**ADDENDUM NO. 2**

**MONTE VISTA ELEMENTARY SCHOOL  
INTERIM HOUSING PROJECT  
GLENDALE UNIFIED SCHOOL DISTRICT**

DSA Appl. No.03-121306  
DSA File No. 19-41

**RESPONSES TO PRE-BID RFI'S**

drawing no.:  
**AS-5**  
drawing of

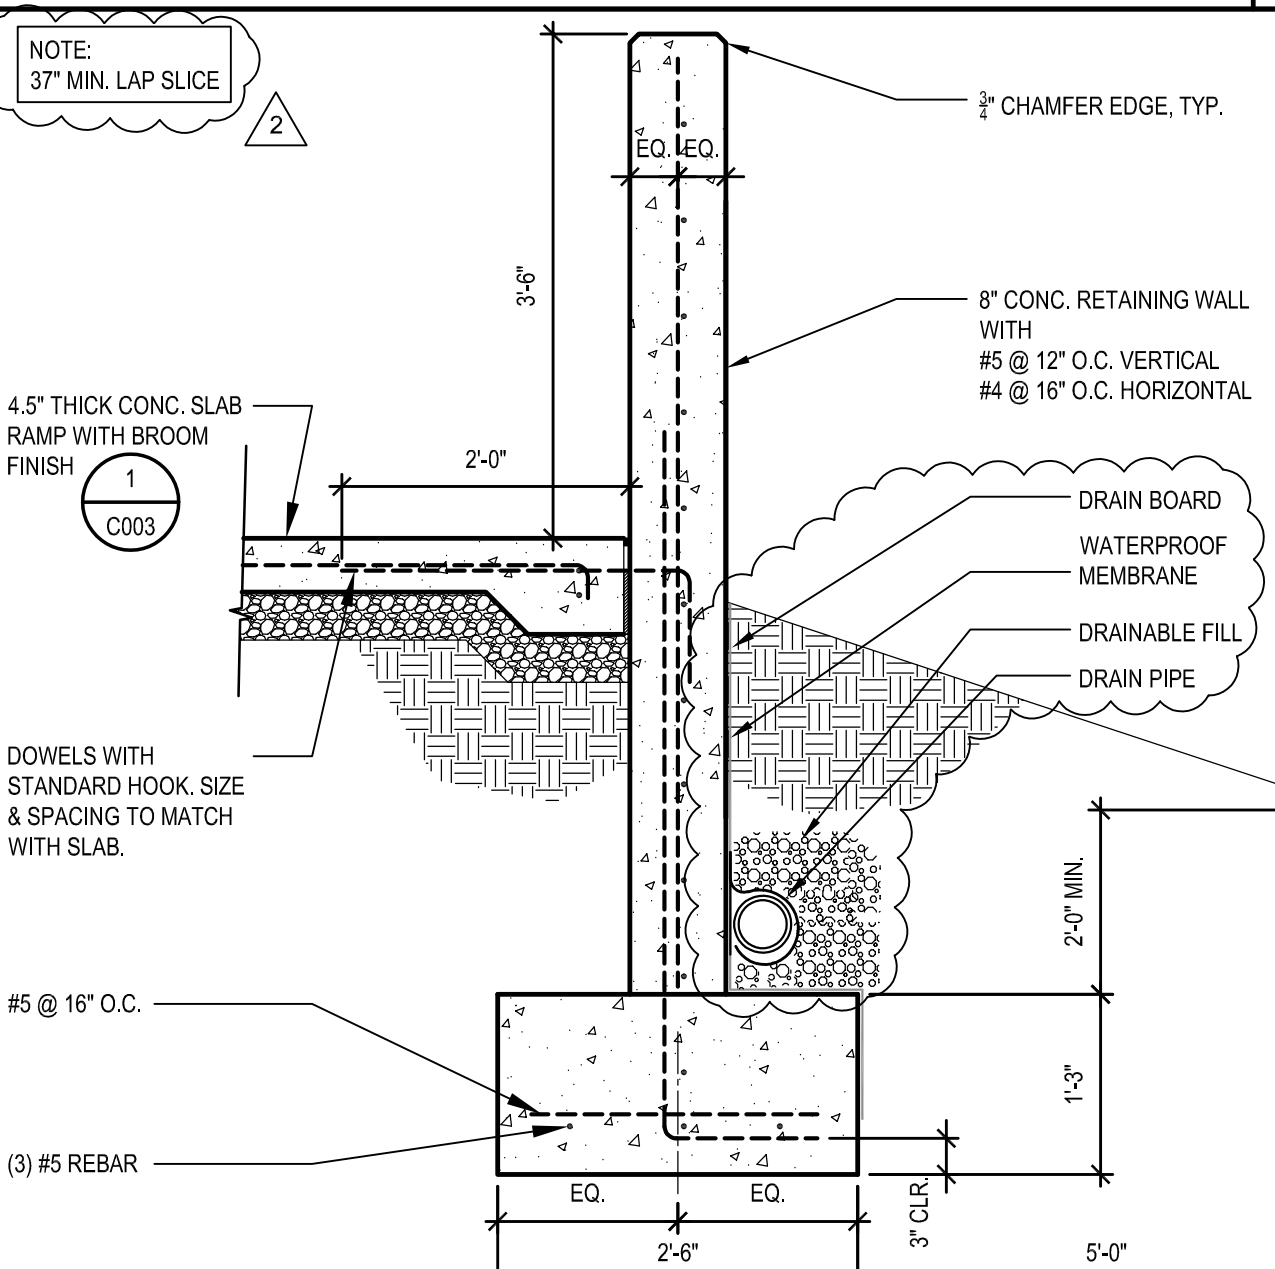
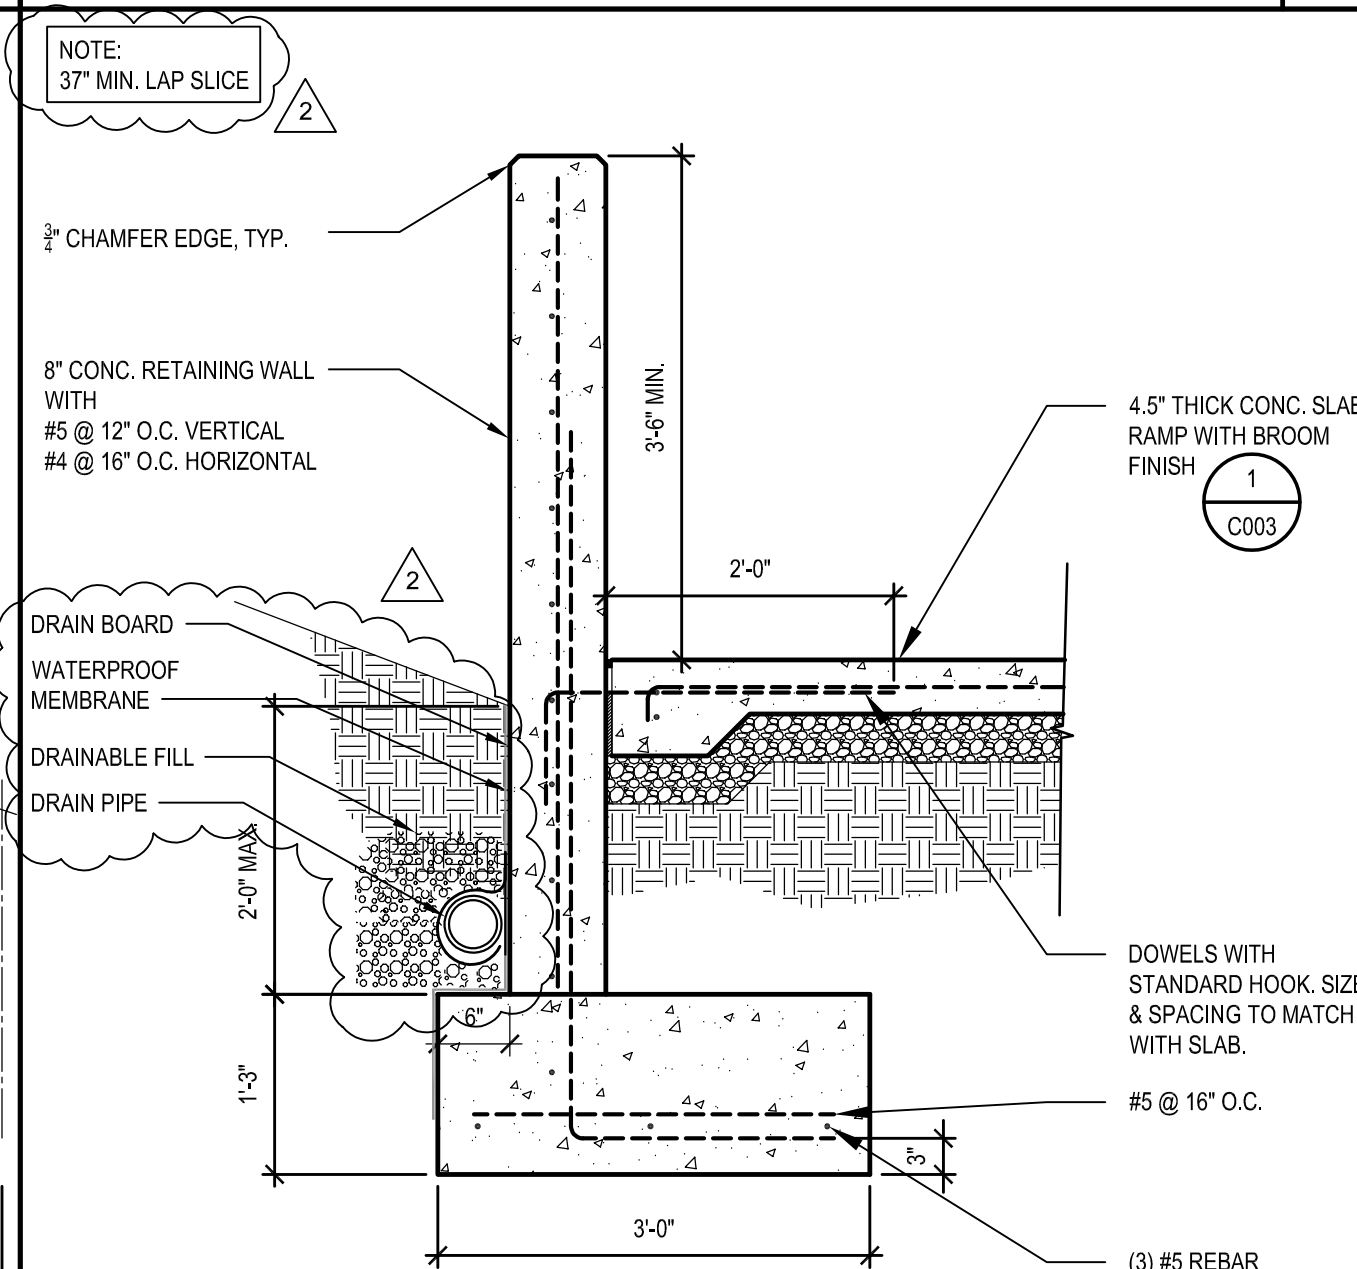
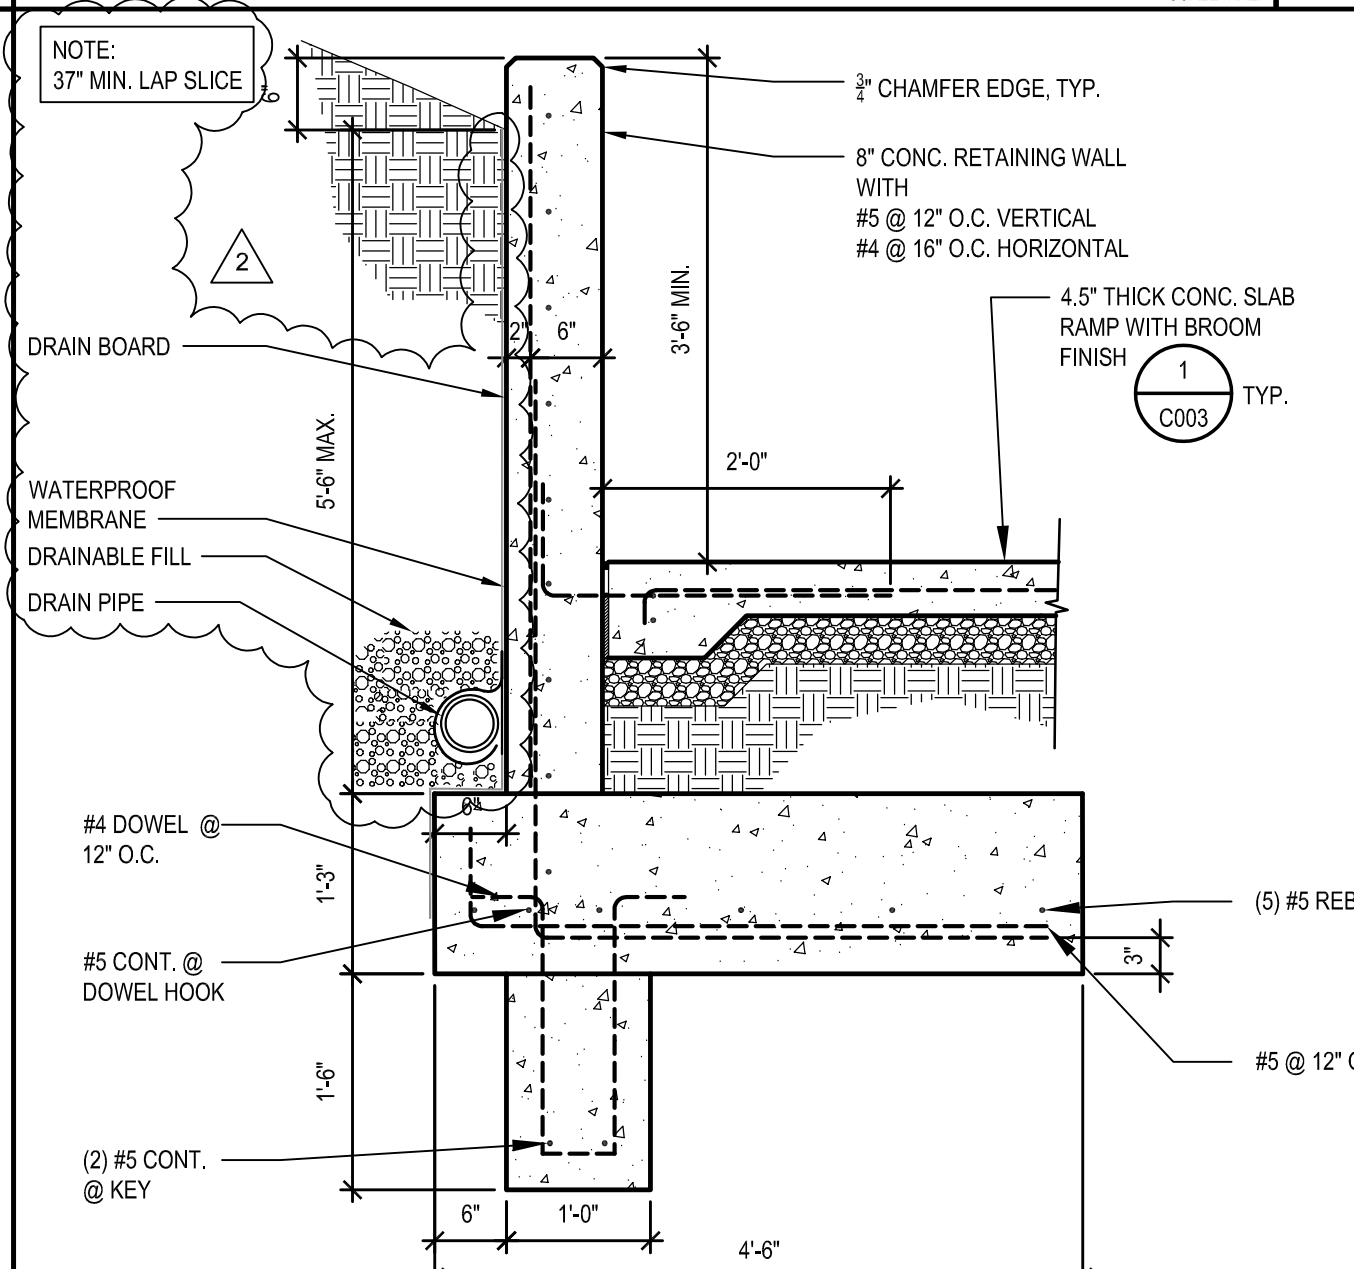
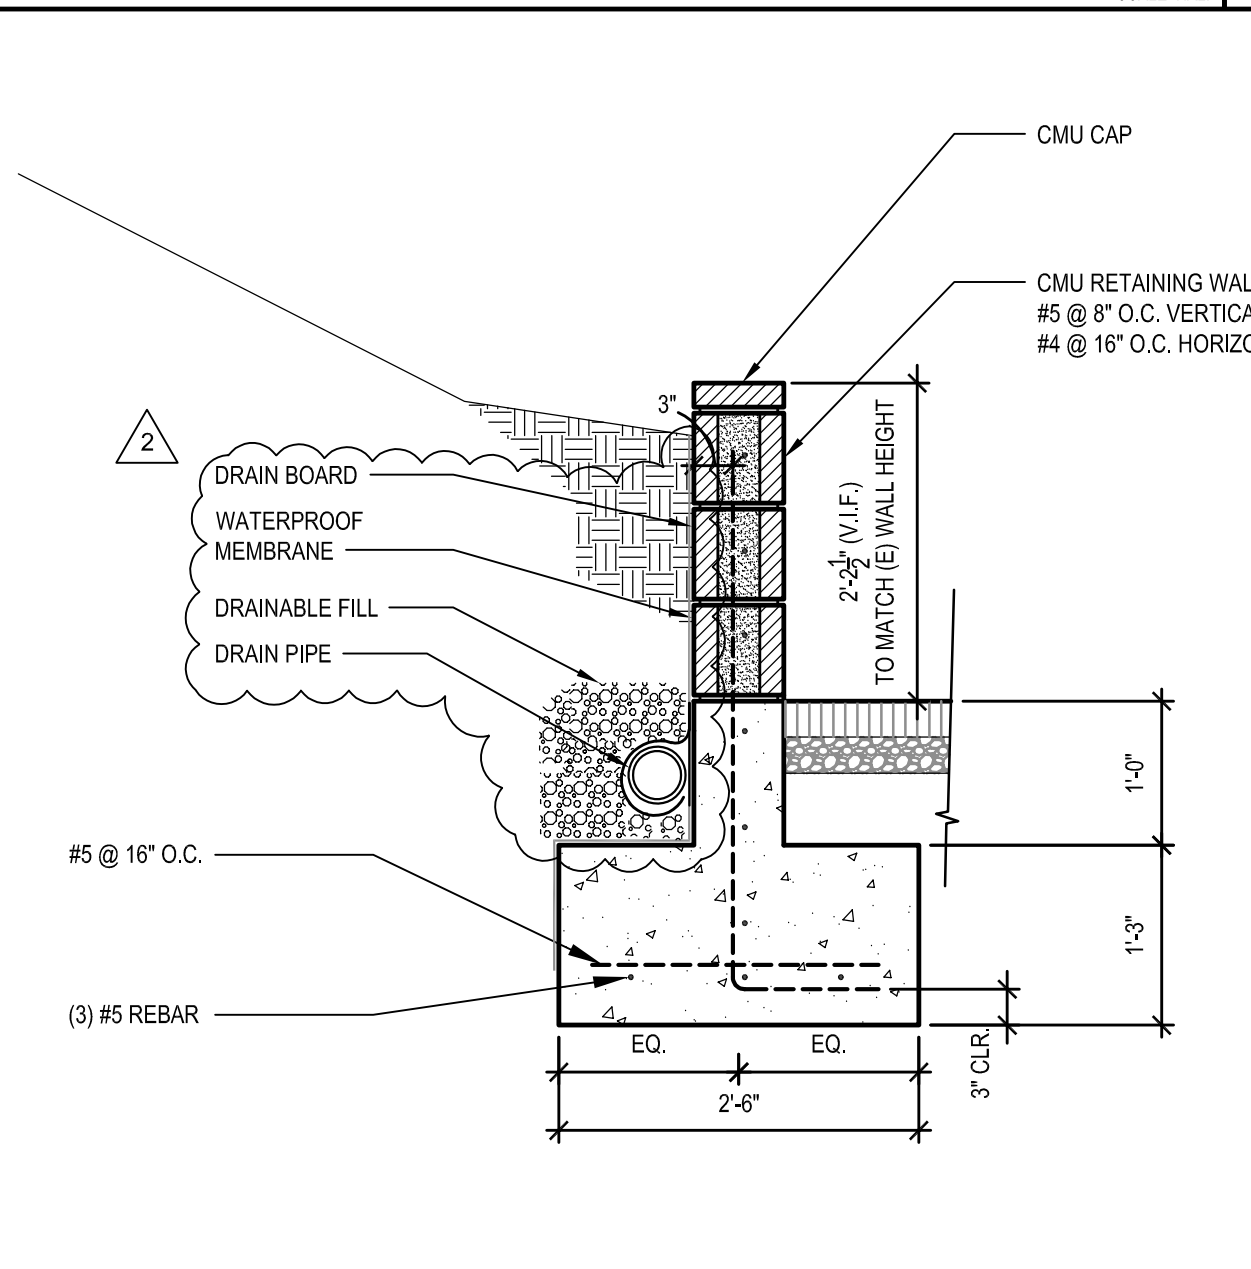
**Response** – ADA path of travel is required for this project. Topographic survey is part of the plans.
16. Reference AS-5  
Retaining walls 1. Please provide lap splice requirements, 2. Please confirm no keyways are required, 3. Please confirm no back or subdrains are required.

**Response** – 1. Min. 37" LAP Splice. 2. No keyways required. 3. Subdrain required or 2" weephole @8' O.C. is acceptable to assure no water pressure to occur. See updated plans in Addendum No.2.

DRYWELL SCALE: 1/2" = 1'-0"

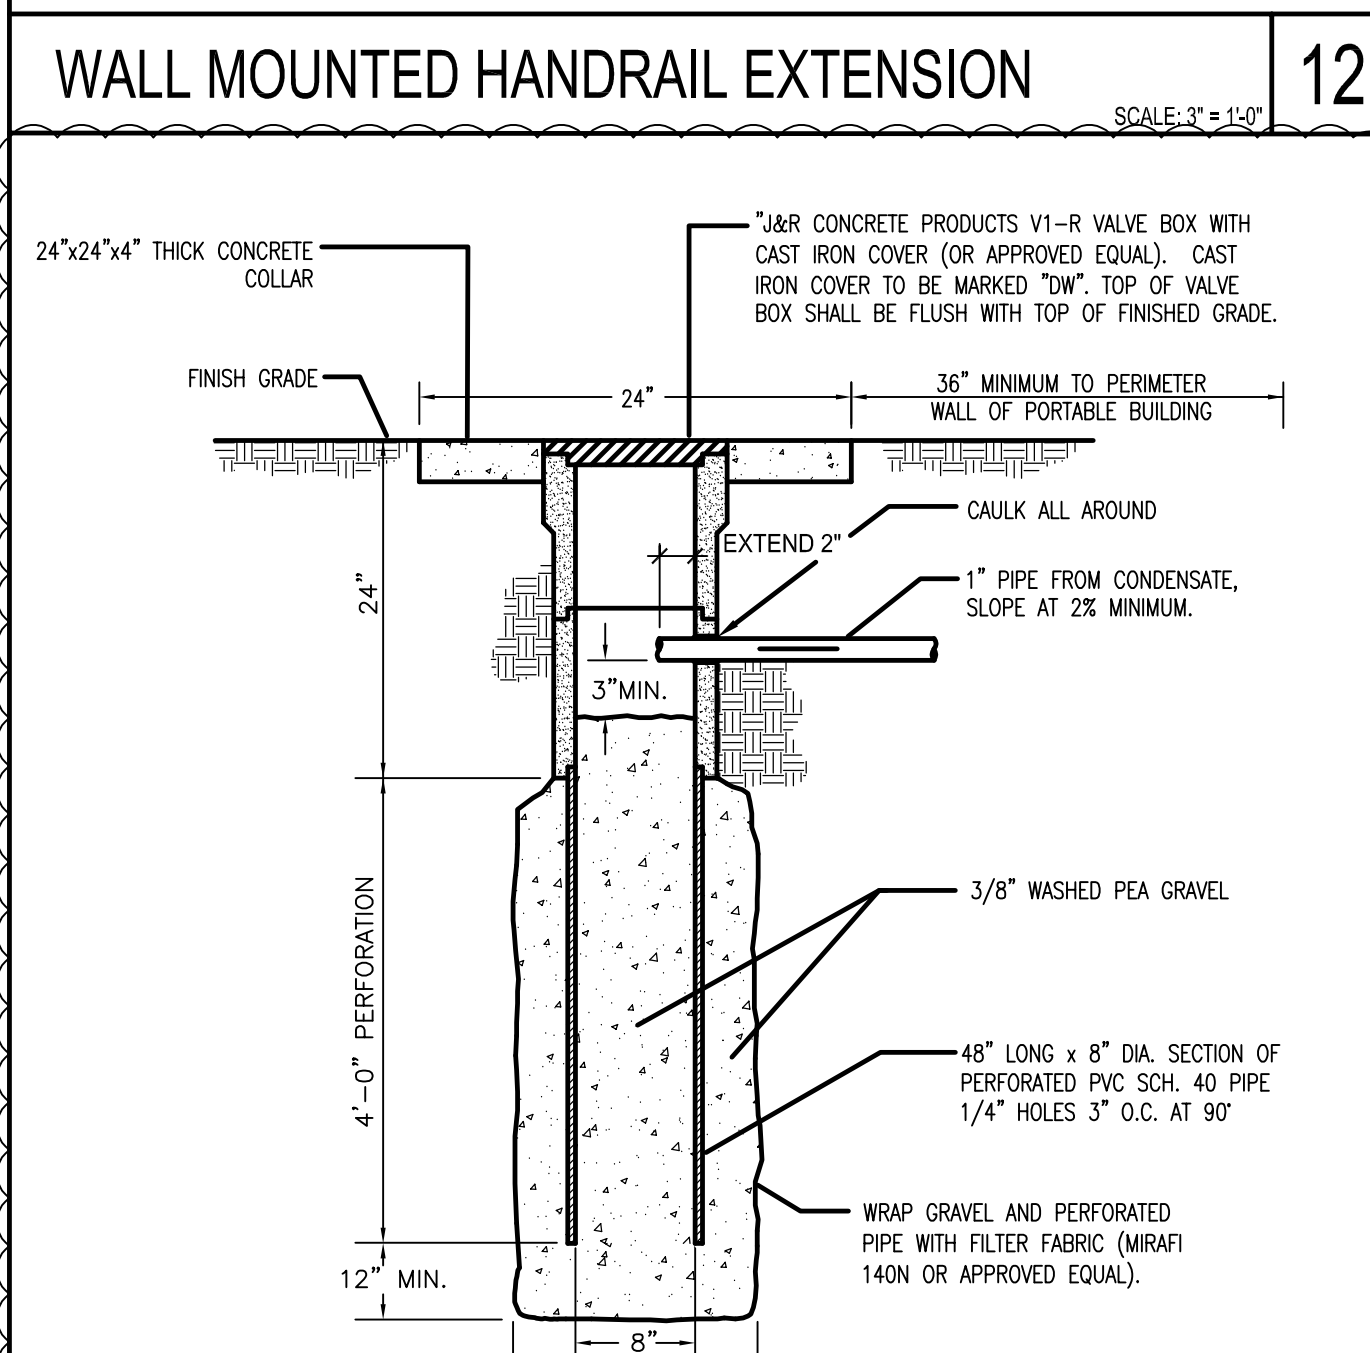
**Response** – The fire alarm system for the relocated portables is a stand alone system.
14. Reference Sheet 2.01  
What is depth of drywells, size well material and specific condensate piping details from condensing units at all five interim housing units.

**Response** – See addendum No. 2 for updated drywell detail.
15. Reference Sheet C002  
Please confirm that meeting ADA cross slope, changes in level and wayfinding requirements from new ramp through existing hardscape towards relocated interim housing is not part of scope of work.
